UNITED STATES PATENT AND TRADEMARK OFFICE

APPLICATION NO.	FILING DATE	FIRST NAMED INVENTOR	ATTORNEY DOCKET NO.	CONFIRMATION NO.
10/789,615	02/27/2004	Henry Earl Finley	23 - 0692	9079
40158	7590	11/01/2005		
WOODS FULLER SHULTZ & SMITH P.C. ATTN: JEFFREY A. PROEHL P.O. BOX 5027 SIOUX FALLS, SD 57117			EXAMINER REESE, DAVID C	
			ART UNIT	PAPER NUMBER
			3677

Office Action Summary

DETAILED ACTION

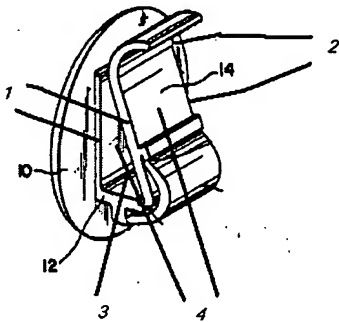
As for Claim 1, Alviti teaches of an ear adornment for adorning an ear of a user, the ear adornment comprising (see accompanying figure below):

a frame member (12) for selectively engaging the ear of the user; and

a sleeve member (10) being removably coupled (the ornament 10 is able to be removed)

to said frame member (12) such that said sleeve member (10) for being positioned adjacent the

ear of the user when the frame member (12) engages the ear of the user, to provide the user with a unique appearance when said sleeve member (10) is coupled to said frame member (12);

wherein said frame member (12) comprises a pair of substantially U-shaped engaging portions (1,2) each having a throat (3) for receiving an upper periphery of the ear of the user, the engaging portions (1,2) each having ends that extend over the ear when said frame member (12) is engaged with the ear, said frame member (12) further comprising a pair of alignment portions (4) extending between corresponding said ends of the engage portions (1,2) to join said pair of engaging portions (1,2) together such that said pair of engaging members (1,2) and said pair of alignment member (4) form a continuous loop.
